ARCHITECT'S SUPPLEMENTAL INSTRUCTIONS

PROJECT:	Lee Lofts III Historic Rehabilitation & New Apartments Salina, KS	Report No.	Three (3)
OWNER:	Overland Property Group Dan Maximuk 234 N. Santa Fe Ave, Suite A Salina, KS 67401	Date	March 12, 2026
CONTRACTOR:	MCP Group 3501 SW Fairlawn Rd. Topeka, KS 66614	Architect's Proj No.	22-3243
		Contract For:	General Construction Mechanical, Electrical

- 1) Contractor to make adjustments as needed and required per the modifications as indicated on attached drawings and in the below descriptions (In response to several items listed on RFIs #18, 20, 22 & 25):

M1.1

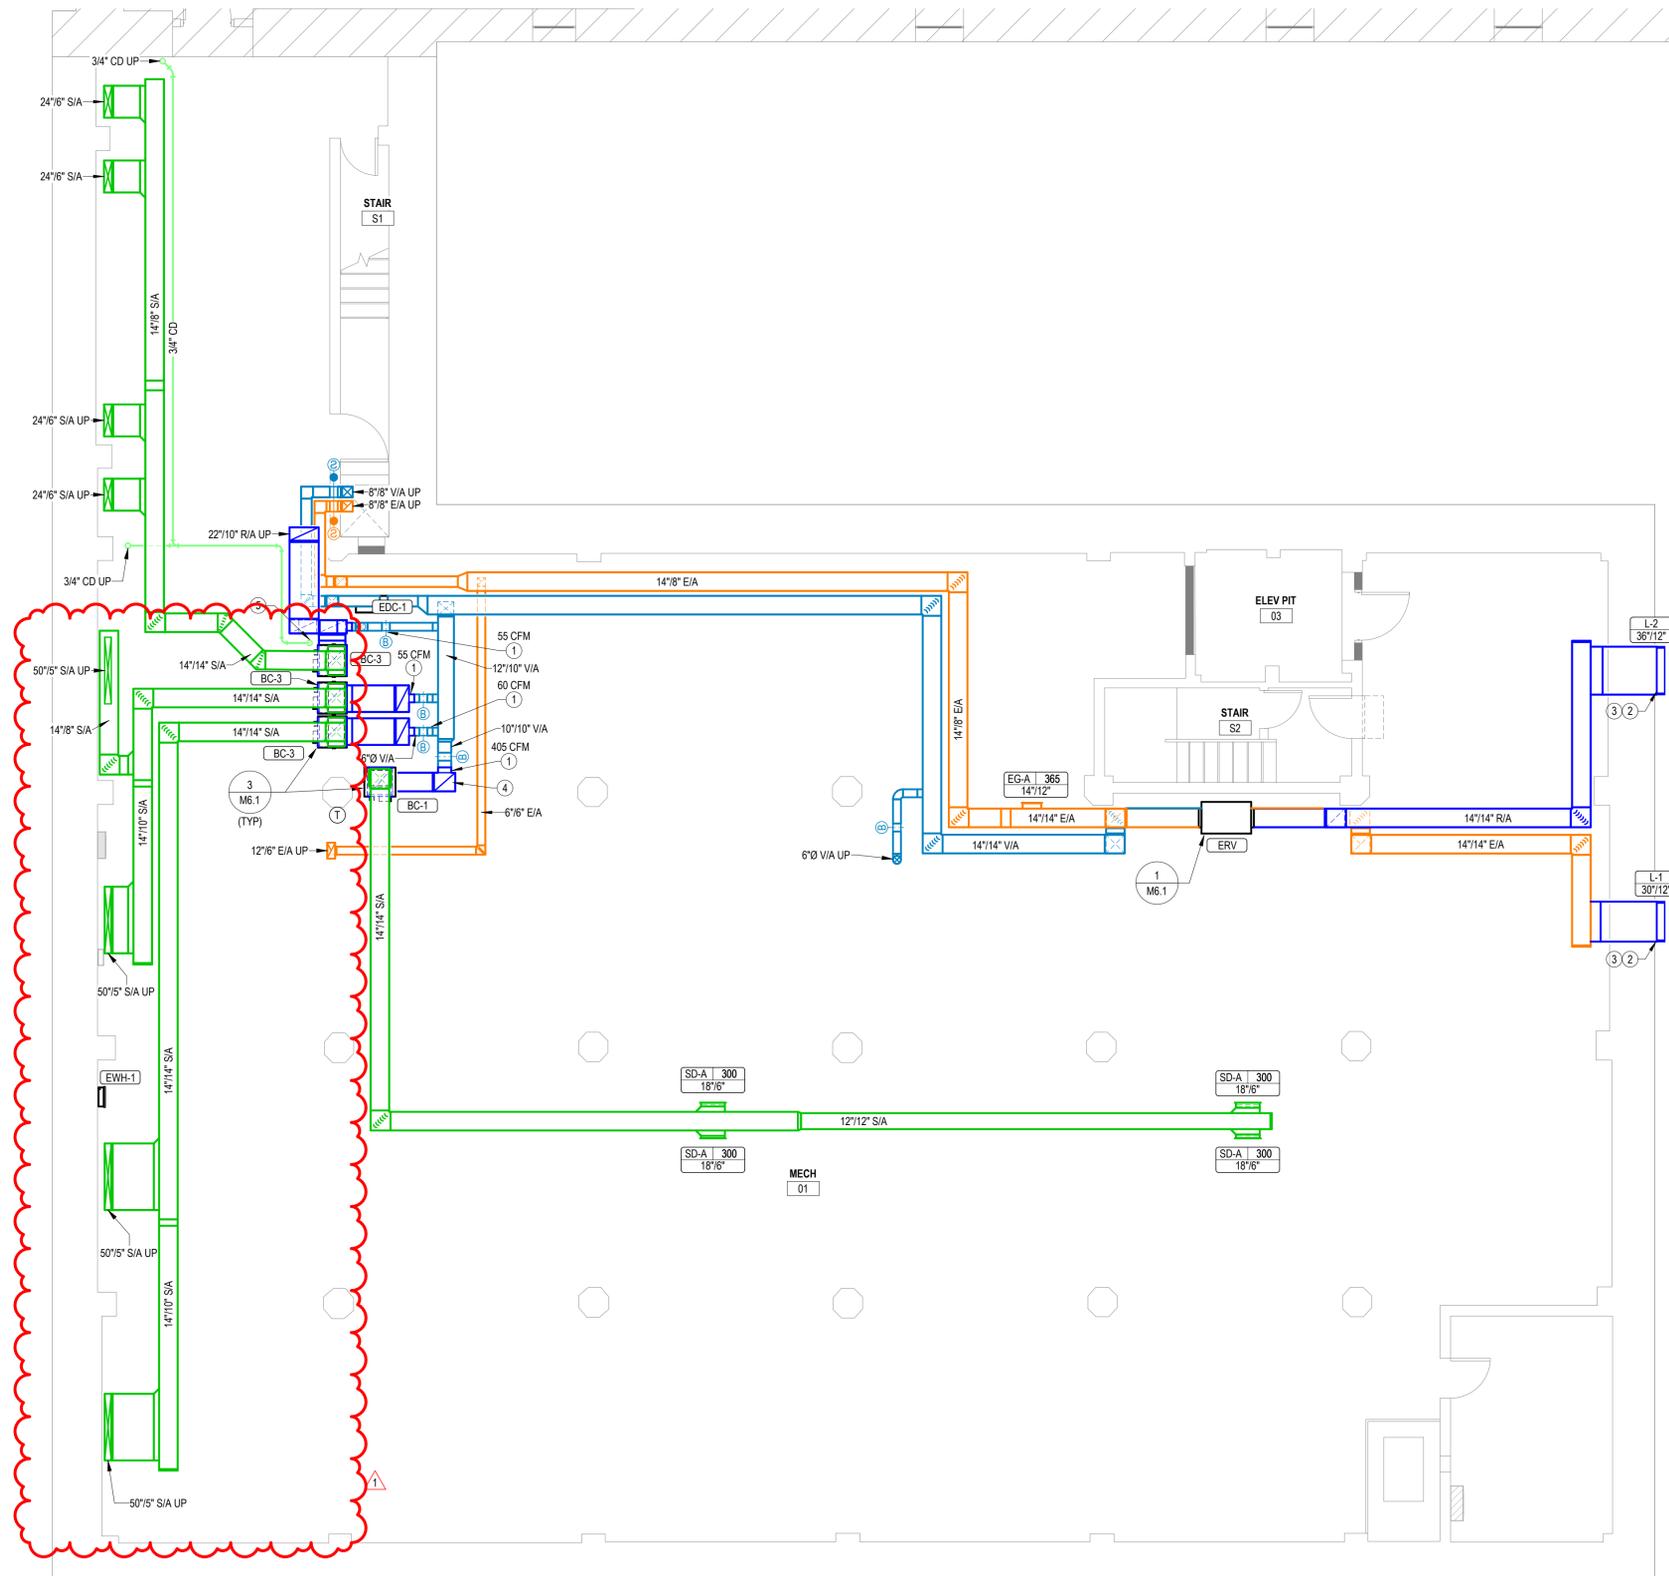
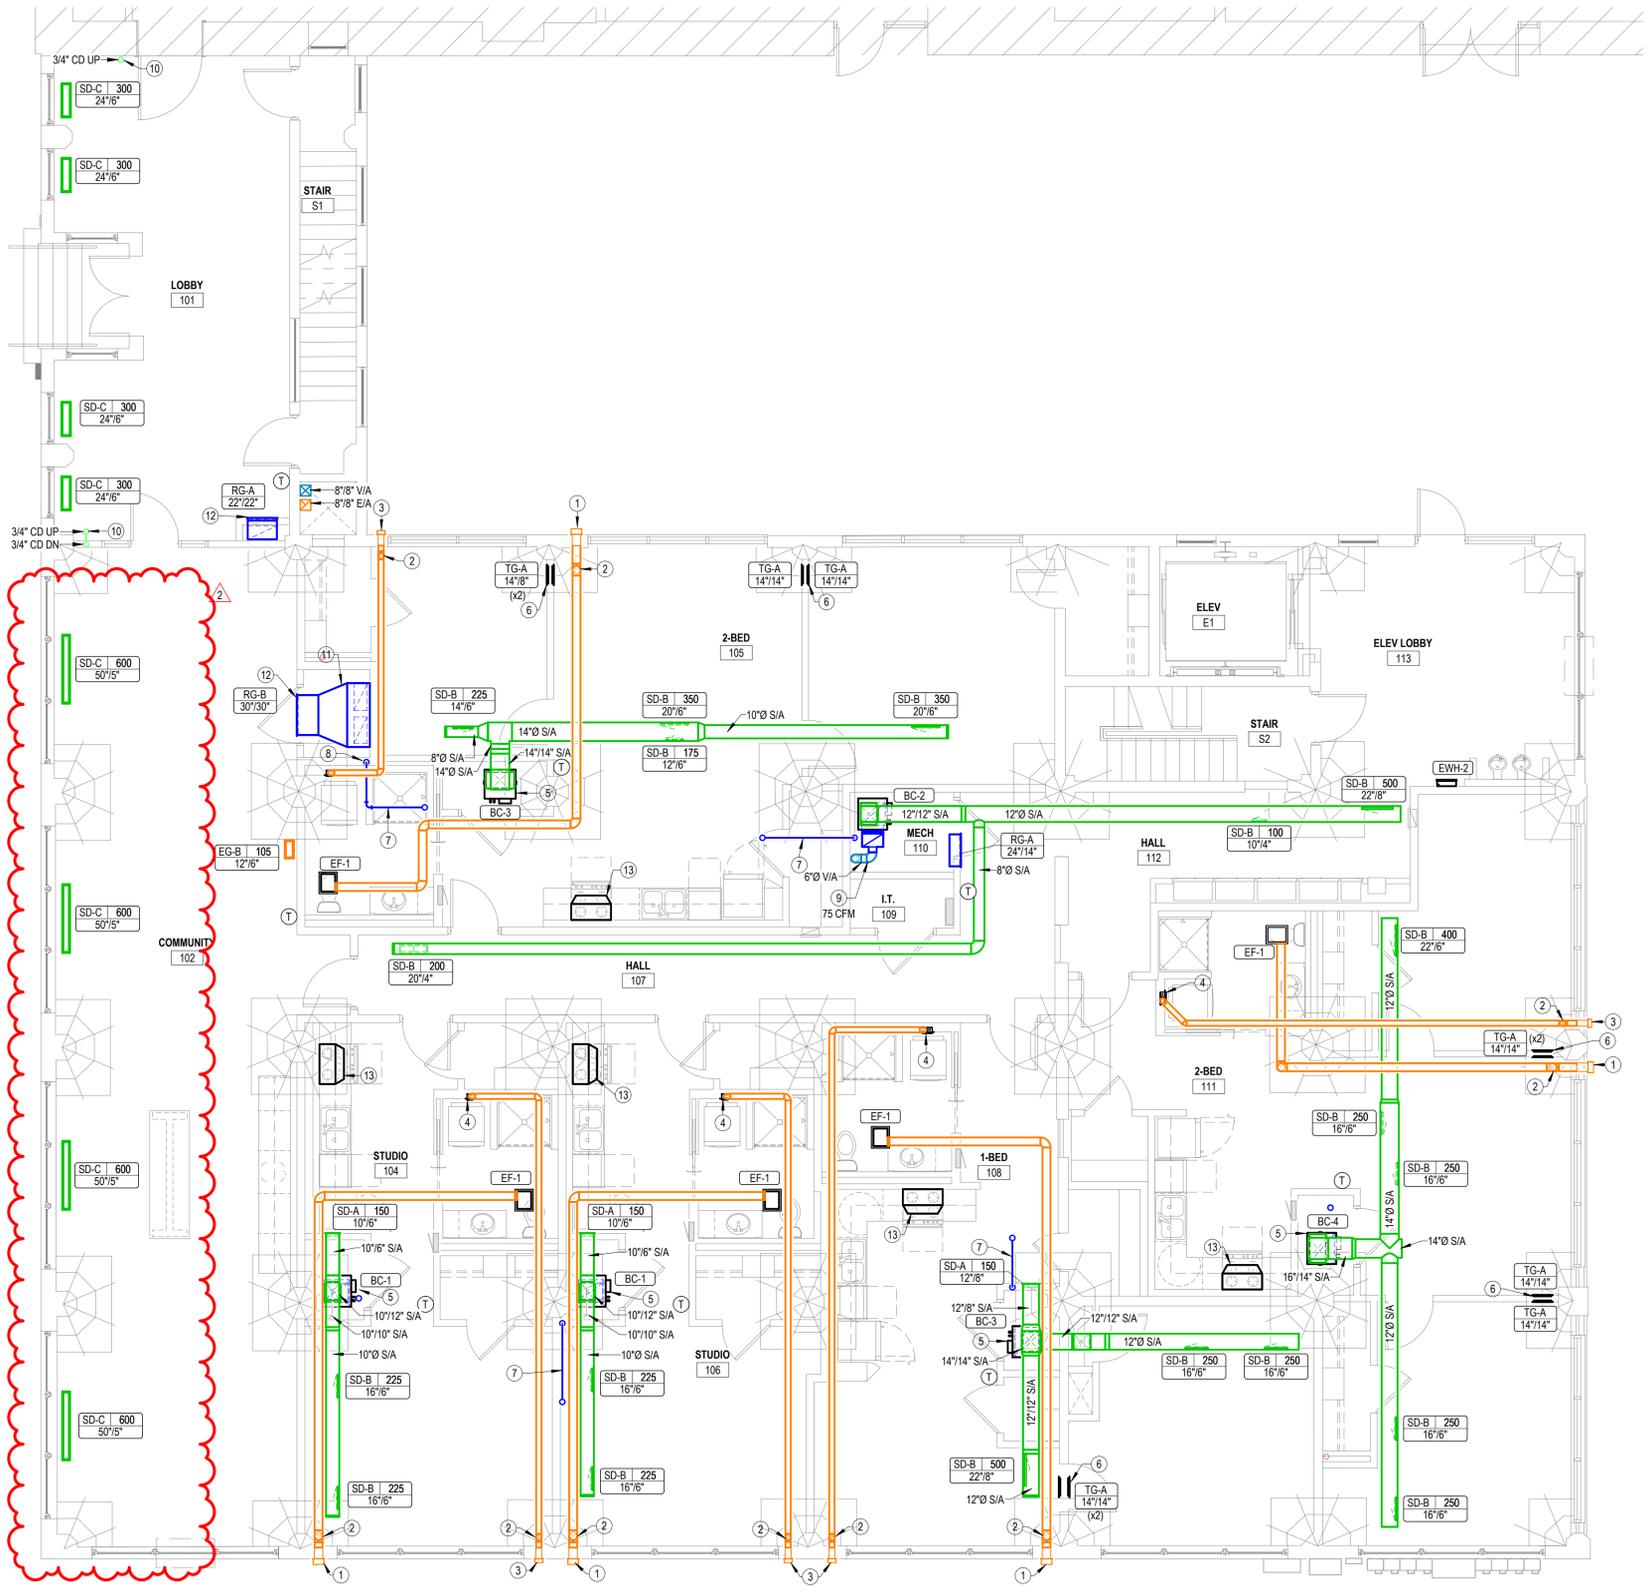
- a. Clarification: Laundry equipment does not need to be Energy-Star Certified.
 - b. Lobby 101 & Community Room 102 – Diffuser sizes and locations have been revised based on existing openings in floor.

- k. MEP – Plumbing, Electrical and Mechanical modified to accommodate changes above.
